Appendix D

Responses to Data Requests

In the Matter of the Application of Snowshoe BESS, LLC for a Site Permit for the up to 150 MW Snowshoe Energy Storage Project in Olmsted County, Minnesota

PUC Docket No. IP-7138/ESS-24-270

OVERALL SEEDING EXHIBIT

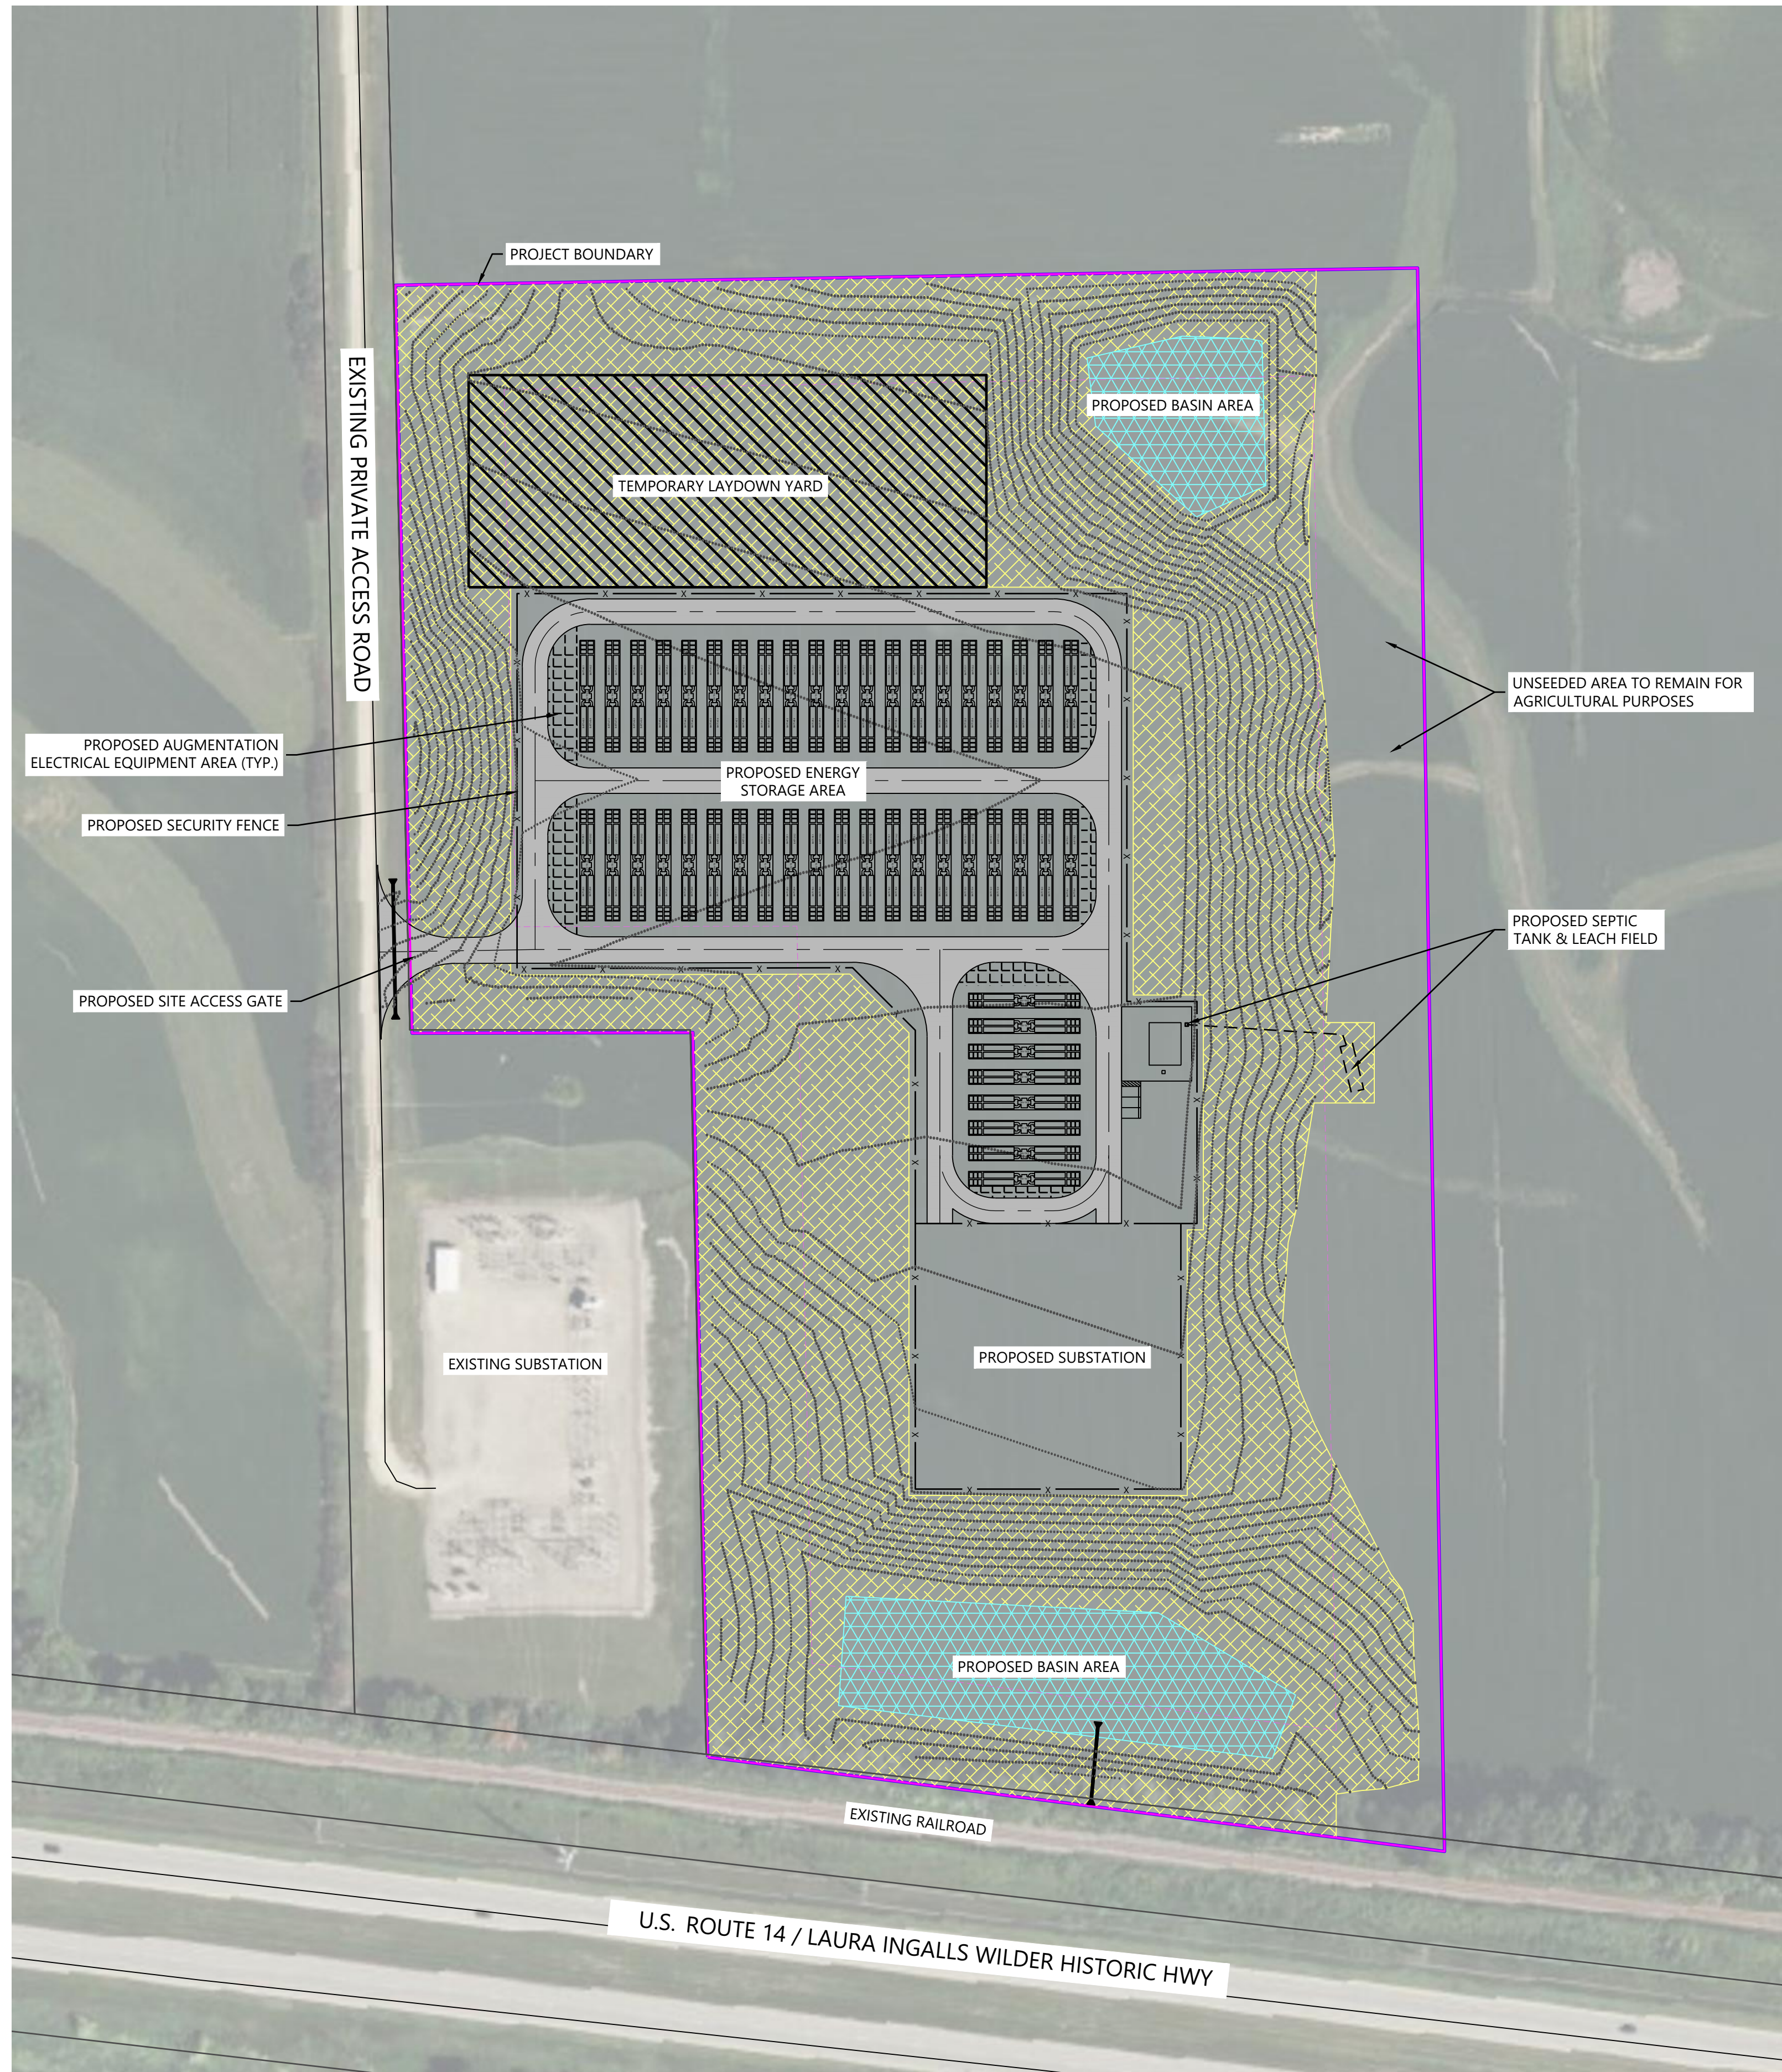
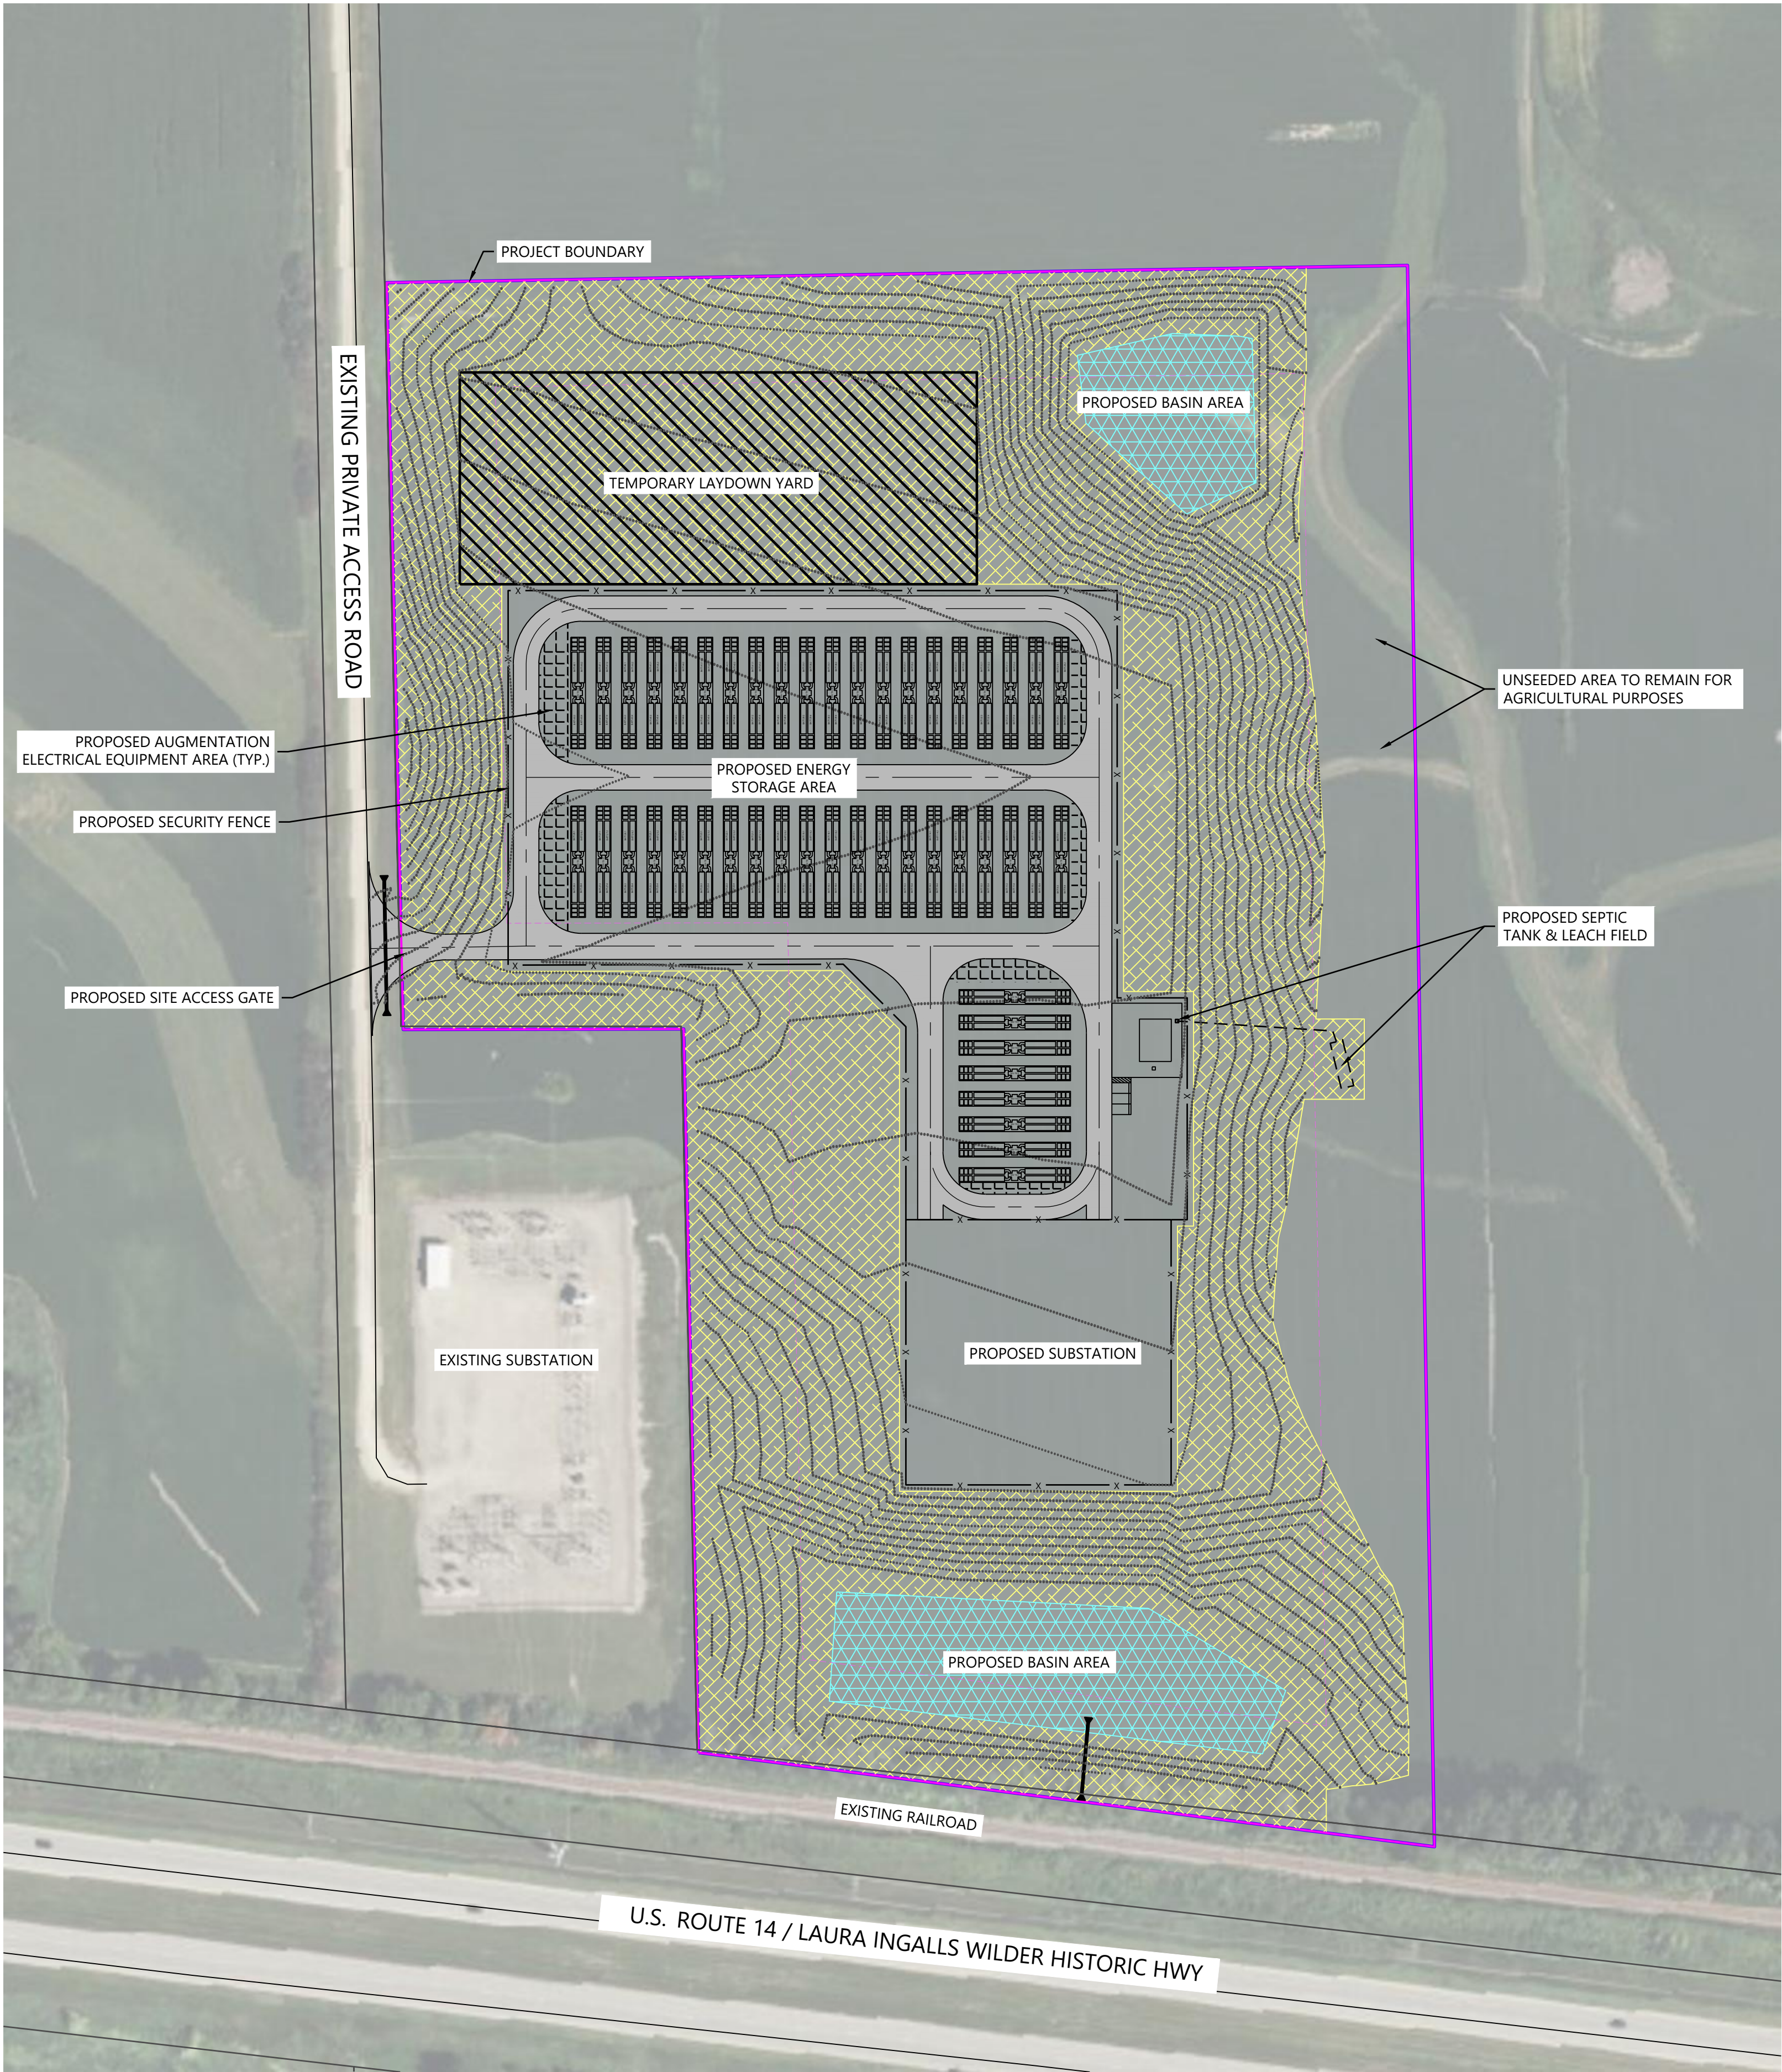
- a. A description of the areas that will be fenced. Figure 2 of the site permit indicates security fencing around BESS facility and substation, while the Overall Seeding exhibit included in the draft Vegetation Management Plan Project shows a larger fenced area that includes the stormwater basins and potentially some areas that may be farmed.

The discussion of site restoration in Section 4.3.3 of the application and in the vegetation management plan indicate that the restoration will include a mix of re-seeding with an open space seed mix (MnDOT Mesic Inslope Mix) and return to agricultural use in some areas. The Overall Seeding Exhibit in the vegetation management plan indicates an irregularly shaped prairie seeding area within the fence line on the eastern portion of the site that borders an area described as “unseeded area to remain for agricultural purposes.”

There was an erroneous label (i.e., Proposed Security Fence) pointing to the Project Boundary that required updating on the VMP seeding exhibit to remove this label, please see updated exhibit attached. The plan legend correctly shows the fenced area where the proposed security fence line surrounds the proposed equipment, but there is no proposed vegetation within the project fence. The groundcover within the BESS yard shall be gravel. The remaining area within the Project Boundary, but outside of the fenced area will be either be seeded, as shown in the Seeding Exhibit attached to the VMP, or allowed to remain in agricultural uses.

Security fencing is proposed around the Project Substation and around the perimeter of the BESS equipment, *not* the Project Boundary. Figure 10 of the VMP incorrectly labeled the Project Boundary as “Proposed Security Fence”. Please see revised Overall Seeding Exhibit attached, which correctly shows the location of the proposed security fence. There is no proposed vegetation or agriculture within the security fence area. The groundcover within the security fenced area and to a distance of up to 5 feet outside the fenced area shall be gravel; areas within the Project Boundary but outside of the security fence will be either seeded or returned to agricultural use as detailed on the attached revised Overall Seeding Exhibit. The portion of the Project Area outside of the fence that is proposed to be seeded is that area that will be graded during Project construction and may not be conducive to row crop agriculture due to the resulting slope of the ground surface. The portion of the Project Area that is intended to be reverted to agricultural use is unlikely to be graded during construction and therefore will retain similar topography to pre-construction conditions, which is conducive to row crop agriculture.

#	DATE	COMMENT	BY	CHK	APR
A	03/12/2025	LABEL UPDATE

Receptor Identifications - Response to DR-8

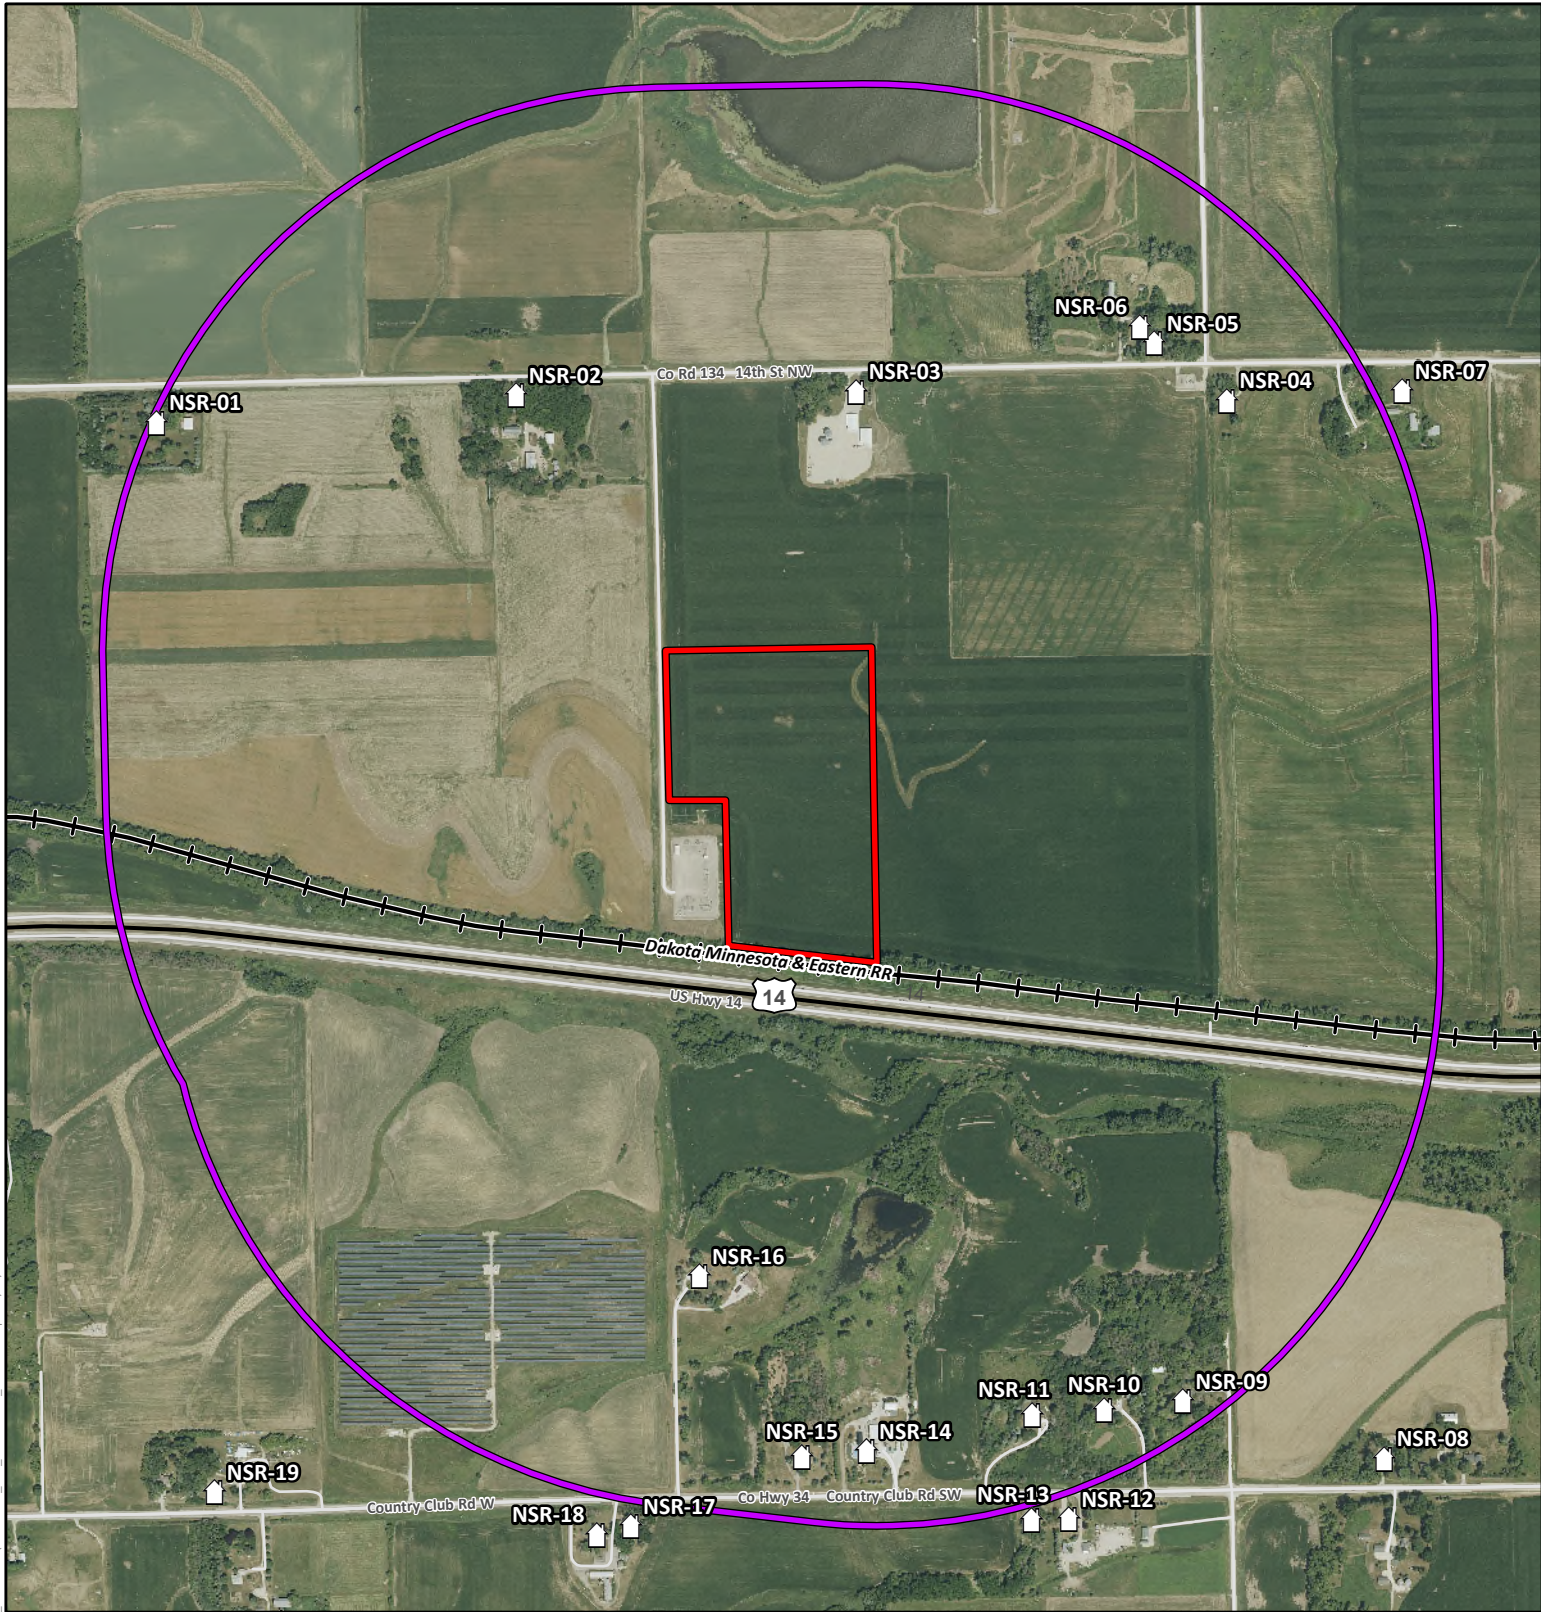
- b. Please provide a map indicating the receptor ids for the 19 nearby residences.
Please see receptor ID map attached (Exhibit 1 – Receptor Identifications).
